City of Sydney Submission to Western Distributor Network Improvements proposal

This document is the City of Sydney's (the City) submission on the Review of Environmental Factors (REF) for the Western Distributor "Road Network Improvements" (the proposal). This submission addresses the City's key concerns about the proposal, its impact and the decision-making process leading to its exhibition.

Figure 4 Biodiversity corridors identified by City (pink and blue lines)

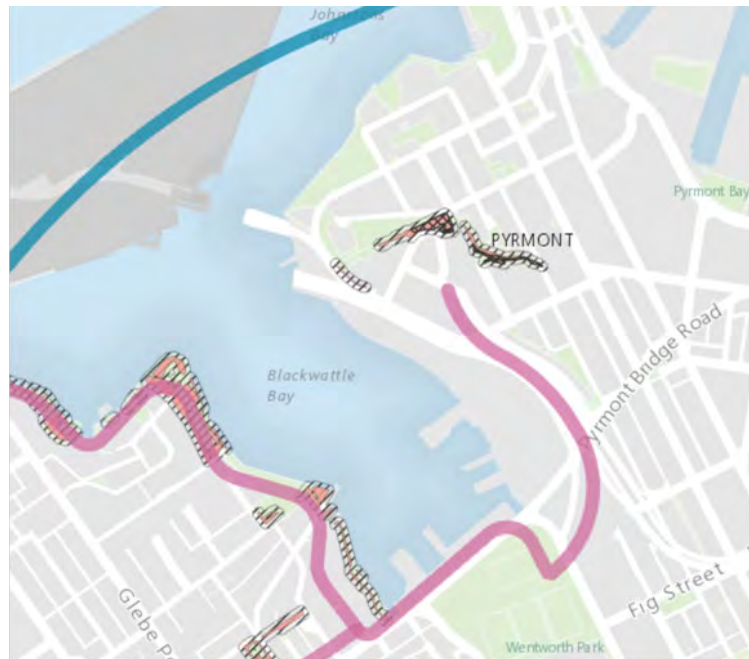
- The City has identified this area as a potential biodiversity corridor (pink and blue lines in Figure 4 below) and there are identified bush restoration sites within the area. In particular, the sandstone cliff face along Bank Street has potential habitat value for indigenous flora and fauna.

- The subject area is very urban with fragmented vegetation with over 500 animal species. The proposed removal of vegetation will adversely impact these animals.
